Groundwater & Wastewater Services
Septic Project File & Data Review Worksheet

GWS File #: 7393 B WASPS App #: 2047

M.C.G.W.S.
File: 7393-B
Lot 7 Old Camden Est.

IMPROVEMENT PERMIT for a RESIDENTIAL ON-SITE WASTEWATER TREATMENT & DISPOSAL SYSTEM

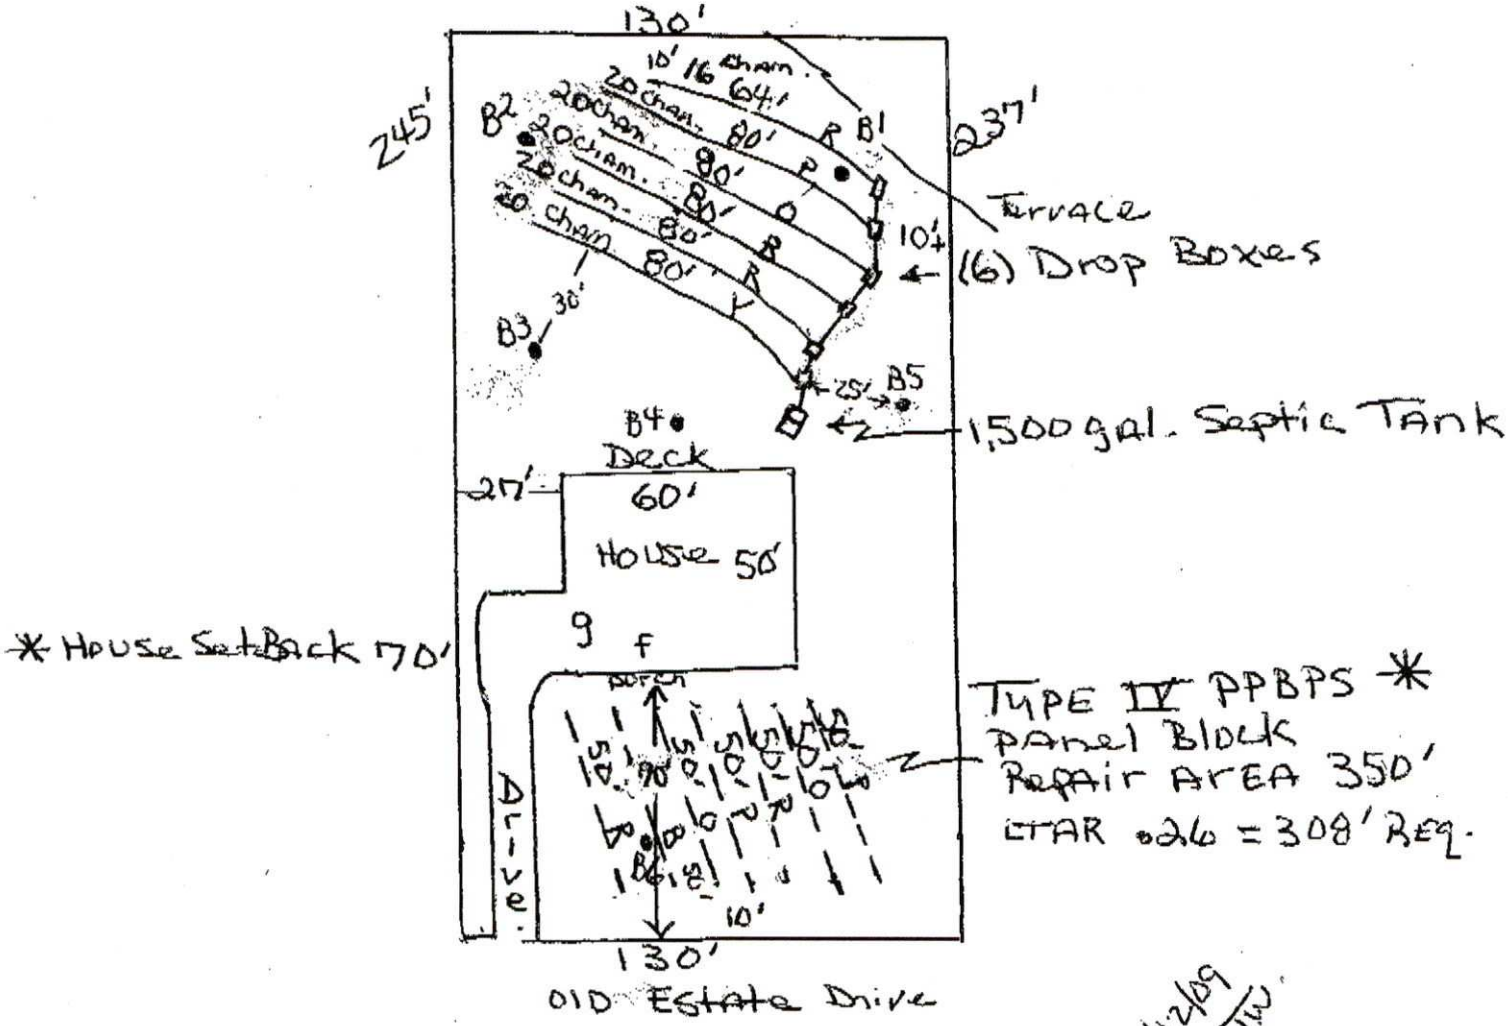
1 hole in repair
need to design @ .26 LTAR
need note in system area
for 3 + 5' unsuitable for 24" min.
trench depth

- 1 HOLE IN REPAIR | SYSTEM HOLE
- NEED 0.26 LTAR DESIGN
- HOLE 3+5 UNSUITABLE FOR 24" MIN T. DEPTH

(4) Bedrm. Gravity Fed, 25% Reduction
Septic Sys. Quick Four Chamber. LTAR .26
1,500 gal. Septic Tank, Drop Box Distribution-(6) boxes
464' As Shown, LTAR .26 = 462' Req.
(116) chambers Req.
* minimum 24" installment Depth, 12" cover

m.c.G.W.S.
File: 7393-B
Lot 7 Old Camden Est.

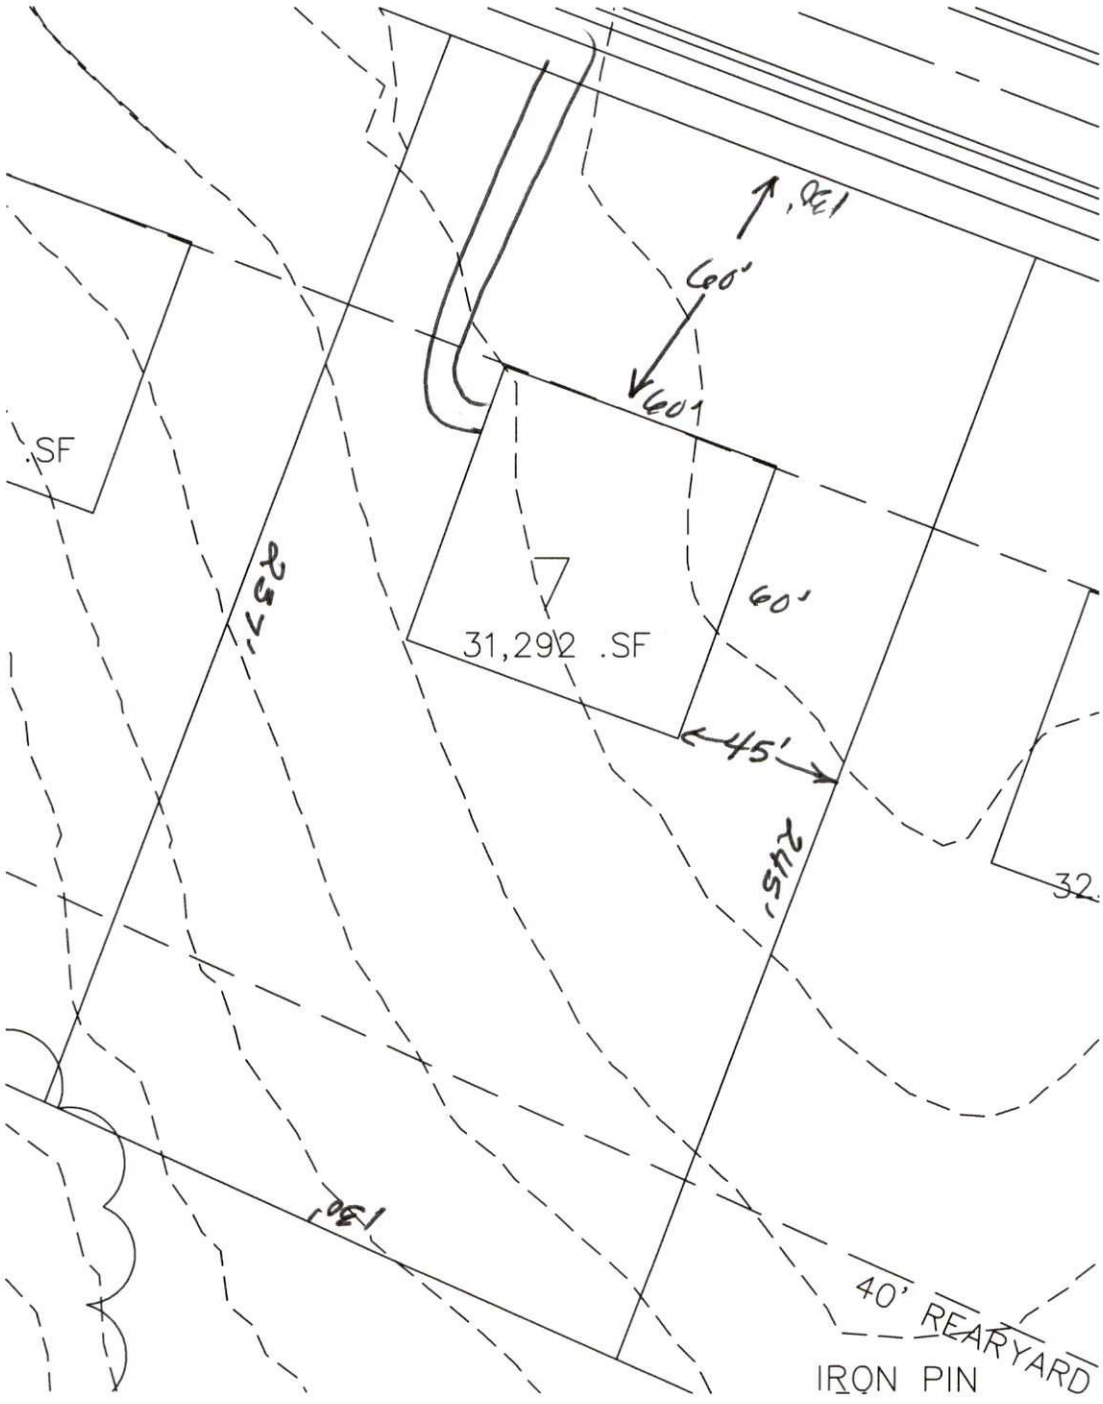
FIELD REVIEW - 12/15/08
D. Cornelius, RS
Approved

(4) Bedrm. Gravity Fed, 25% Reduction
Septic Sys. Quick Four Chamber; LTAR .275
1,500 gal. Septic Tank, Drop Box Distribution-(5) boxes
436' As Shown
(111) chambers REQ.
* minimum 24" installment Depth, 12" cover
